**NORTH OAKVILLE SUBWATERSHED
MANAGEMENT STRATEGY
(WITHOUT PREJUDICE)**

Mediation Item: Hydrology model and hydraulic model for a portion of Joshua's Creek floodplain mapping (May 31, 2007)

Mediation Item: Regional Storm Flood Protection (May 30, 2007)

Figure A. A hypothetical example illustrating relevant erosion threshold procedures in the context of Subcatchment Areas.

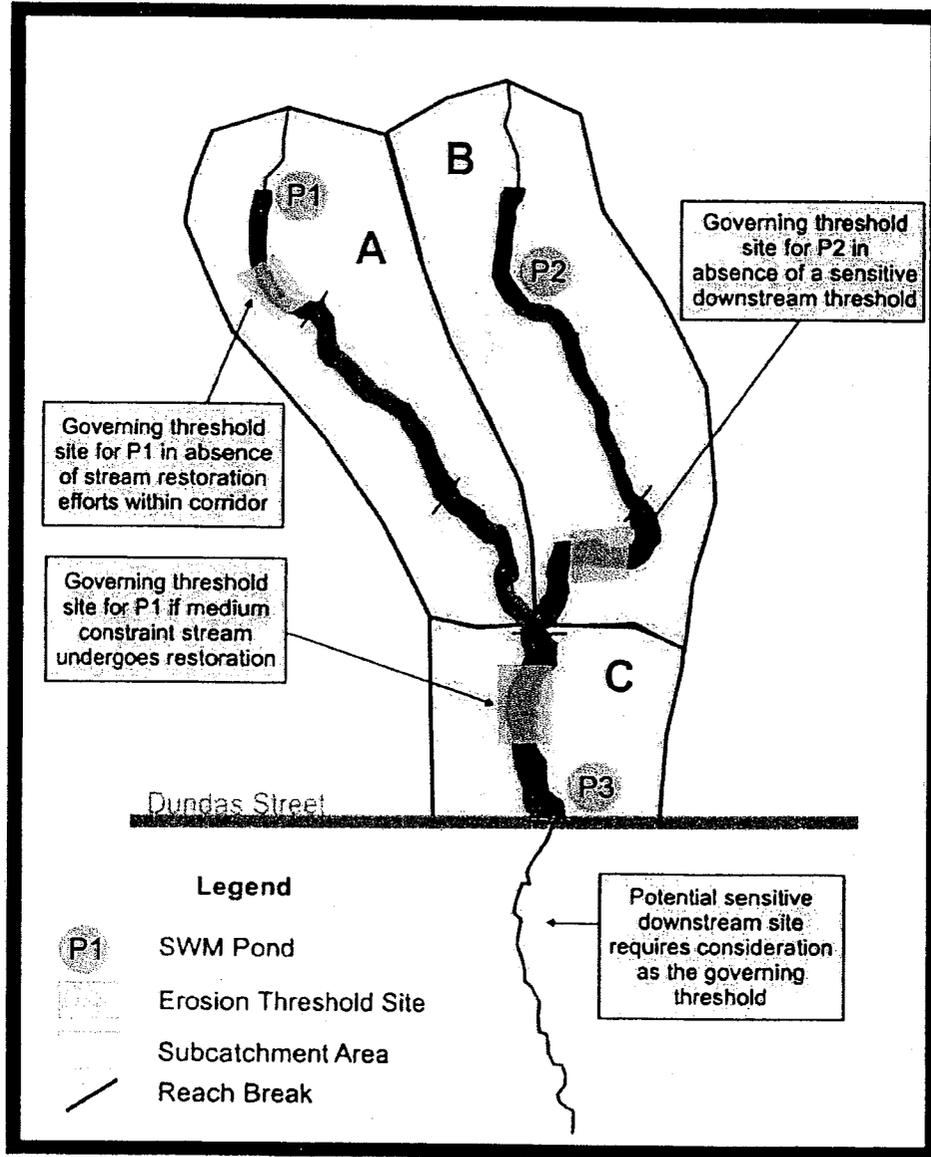
1. Downstream of a proposed SWM facility, the most sensitive (or less stable) reach will be identified through a Rapid Field Assessment or suitable synoptic level survey. As a general approach, the spatial extent should include the stream length to the next downstream confluence and at least one reach (as defined in the EIR stage) beyond to ensure that highly sensitive channels, in relative close proximity to the SWM Pond, are included in the assessment (**Figure A**).

warranted in each watershed, it is possible that one, sensitive downstream value may govern (see **Figure A**).

It should be noted that, while the erosion threshold assessment is conducted on a single Subcatchment Area basis, the proponent must be aware that areas downstream need to be considered when selecting the most sensitive reach as depicted in **Figure A**.

Figure 6.3.15a

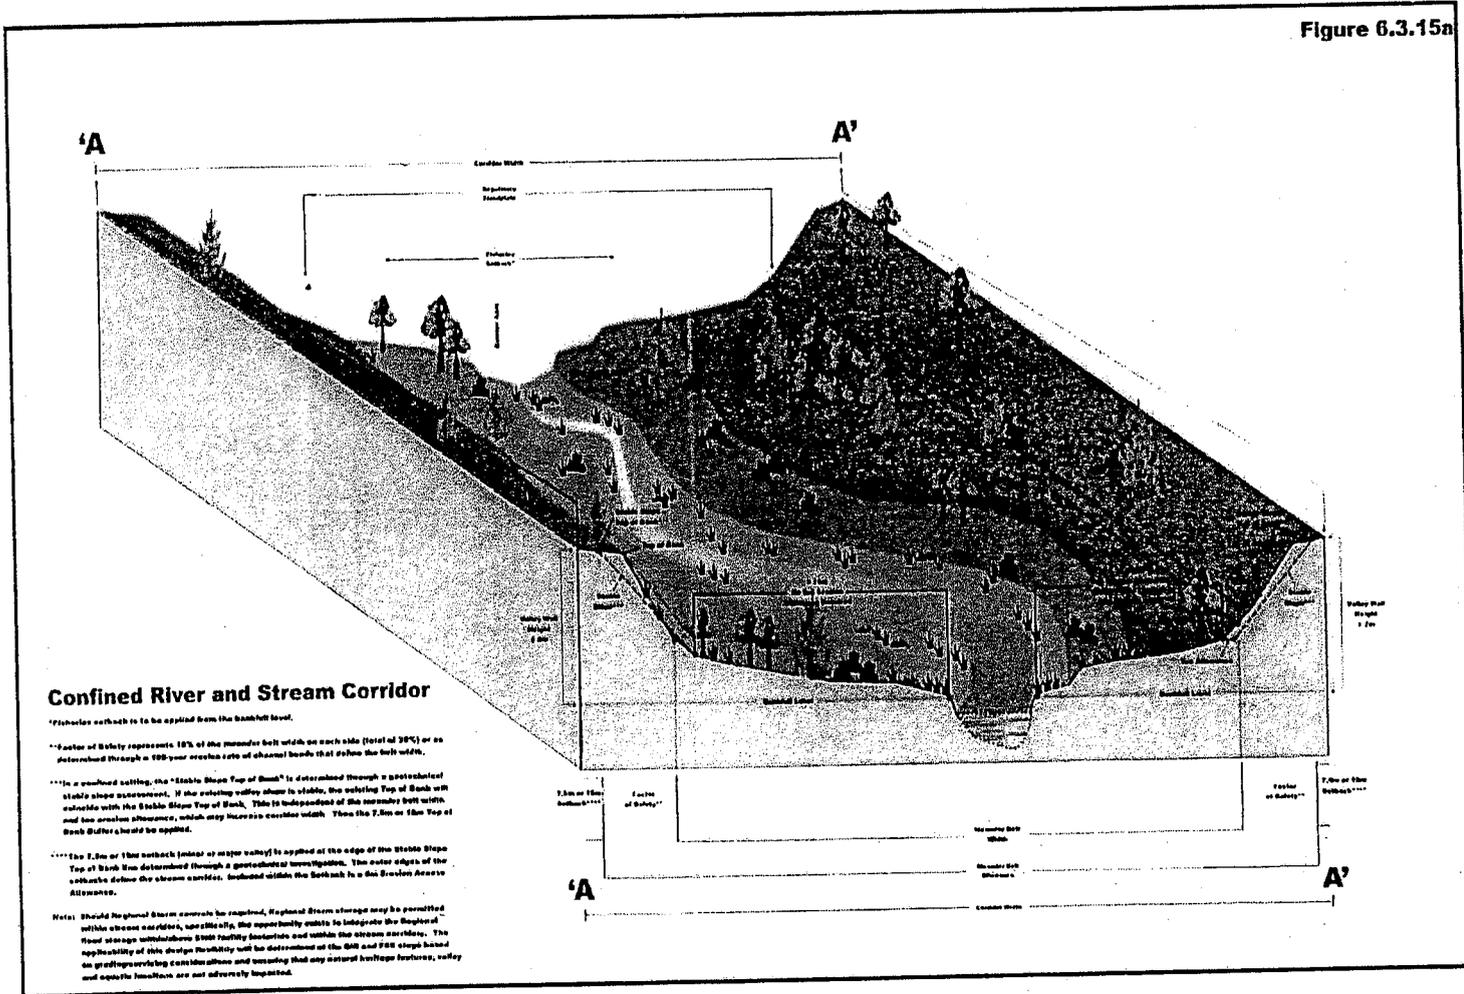
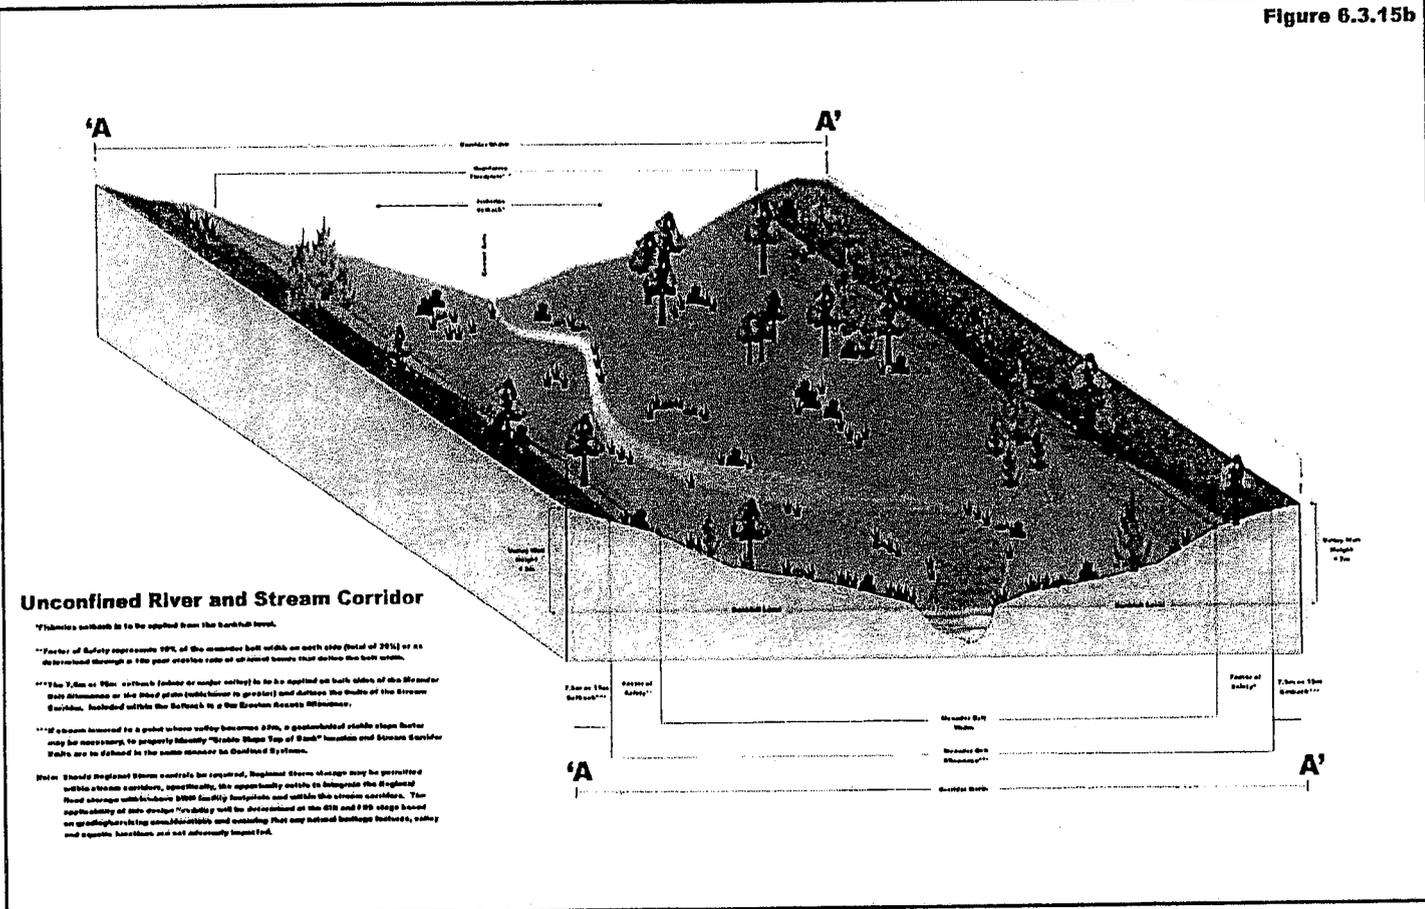
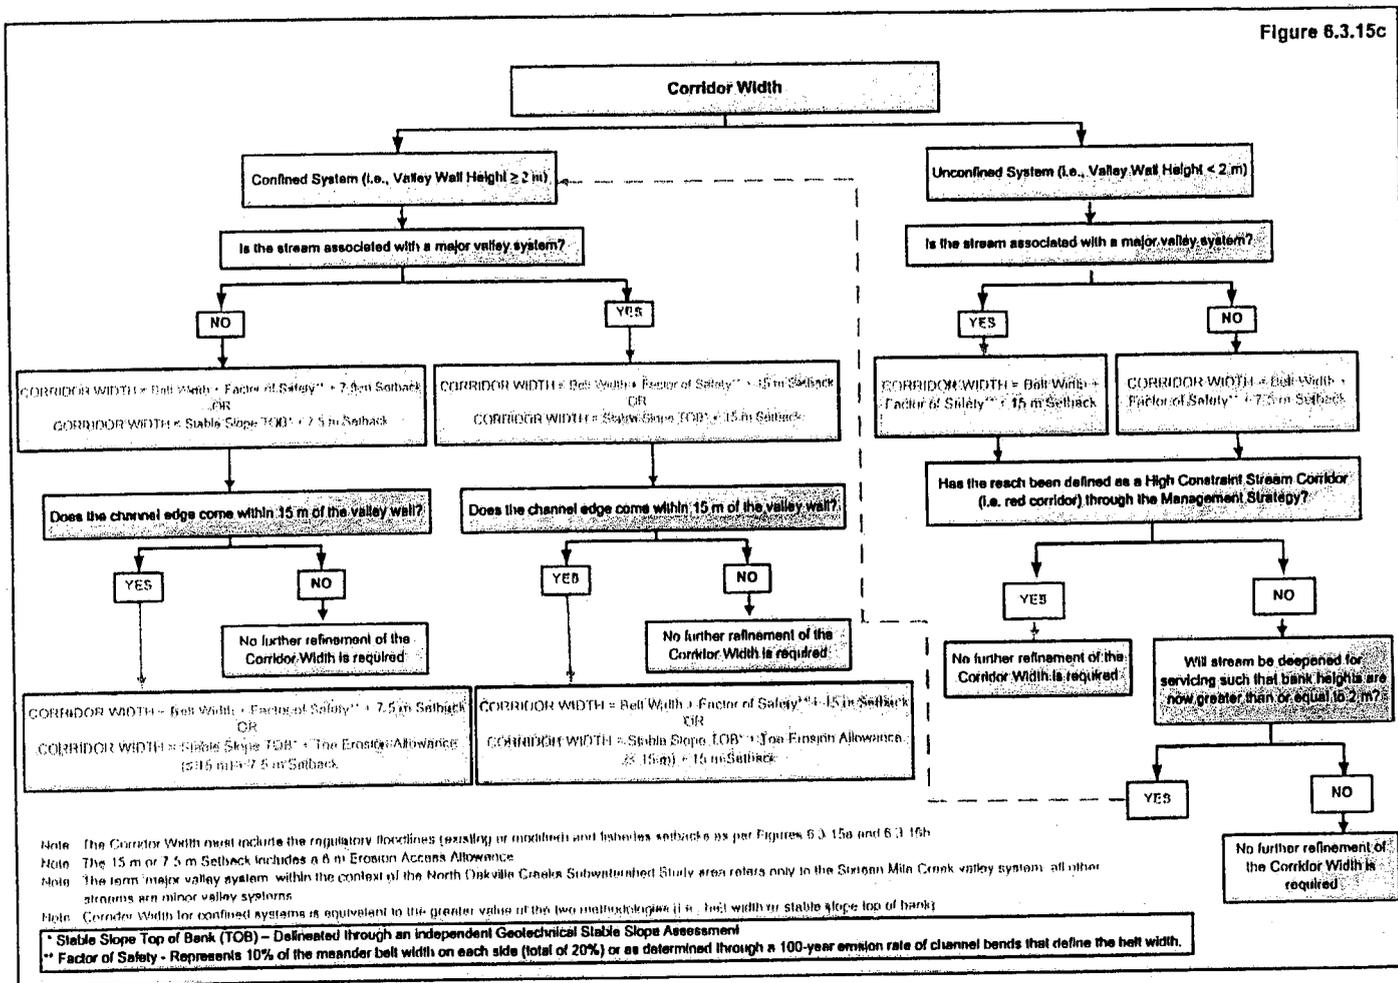
See attached Figures 6.3.15a and 6.3.15b (Confined and Unconfined River and Stream Corridors) and Figure 6.3.15c (Flow Chart):

Figures 6.3.15 a, 6.3.15 b and 6.3.15 c agreed upon in mediation will be added to the Secondary Plan as Appendix 7.4. In addition, a policy is to be added to section 7.4.7.2 of the Plan as follows:

Figure A - SWM Pond Discussions
 June 19, 2007
 Without Prejudice

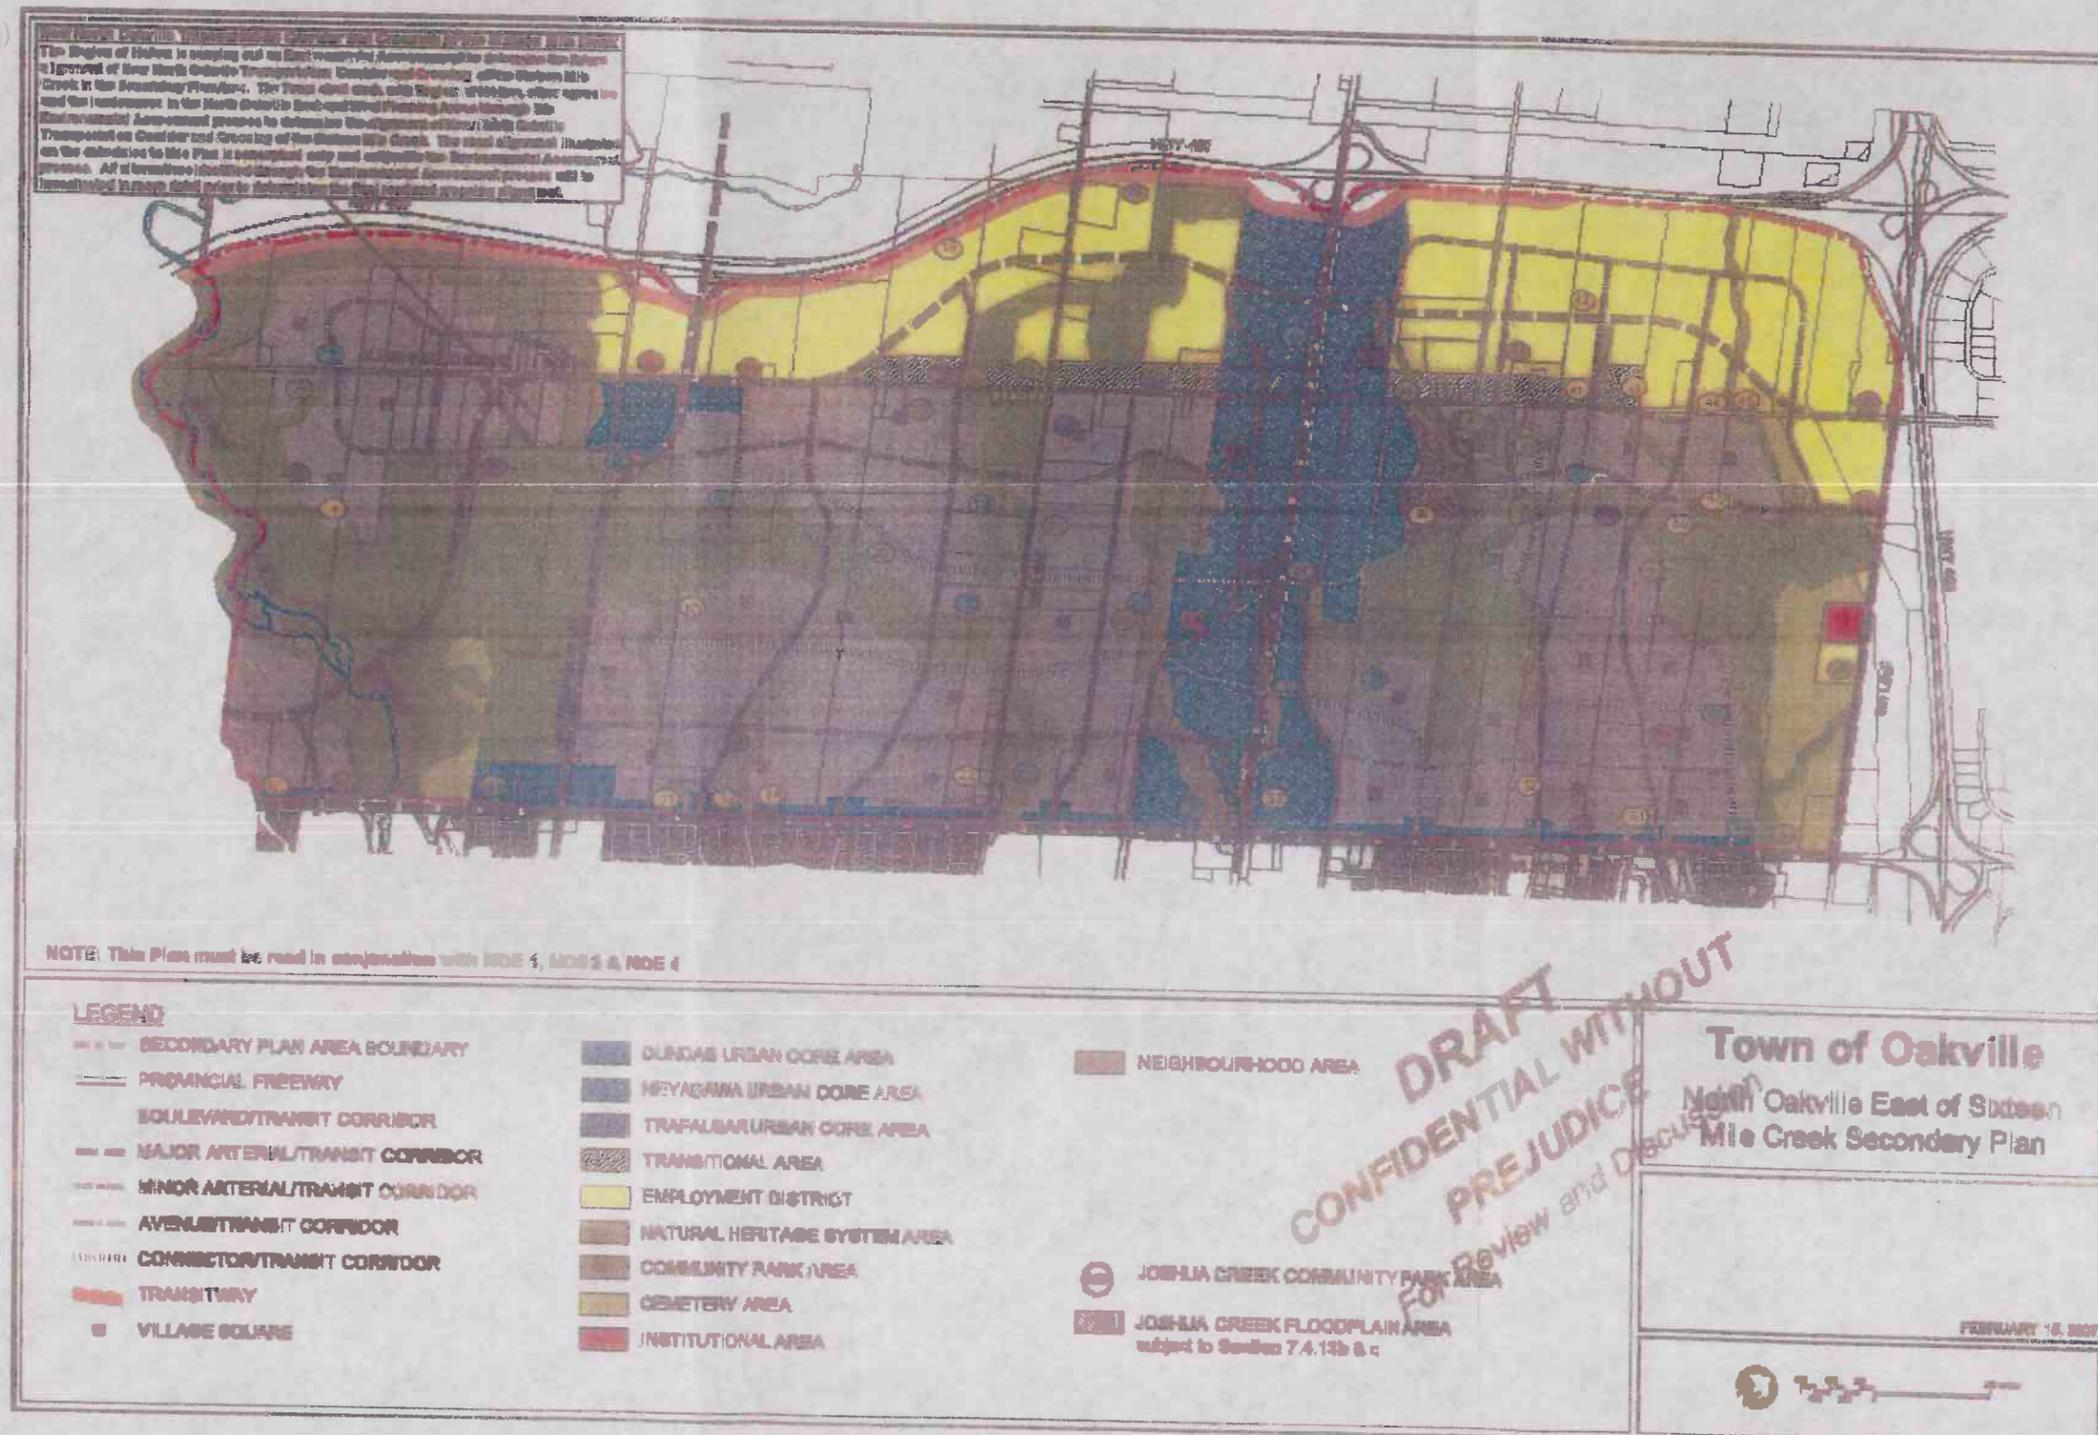
- a) All SWM ponds illustrated in the Town's NOCSWS (August 2006) and the NOMI SWS (August 2004) along with a few suggested new ponds are shown on Figure A. As part of these discussions, SWM ponds were numbered for reference purposes only.

Table A Comments on Subwatershed Study Stormwater Management Pond Locations (See Figure A for SWM pond locations)	
Pond	Comments
1	<ul style="list-style-type: none"> • Pond not agreed upon
2	<ul style="list-style-type: none"> • Pond removed, subject to confirmation of drainage area at EIR stage • Best Management Practices approach will be used in this drainage area that is less than 5 hectares in size.
3	<ul style="list-style-type: none"> • Pond needed; outlets to SMB-3
4	<ul style="list-style-type: none"> • Pond needed; outlets to SMB-4
5	<ul style="list-style-type: none"> • Pond needed; potential to be combined with Pond 5a; to be addressed at EIR stage
5 (a)	<ul style="list-style-type: none"> • Pond needed; potential to be combined with Pond 5; to be addressed at EIR stage
6	<ul style="list-style-type: none"> • Pond needed in approximately this location to outlet to SMA-9
7	<ul style="list-style-type: none"> • Pond removed on the understanding that Pond 7 is combined in Pond 6; to be addressed at EIR stage
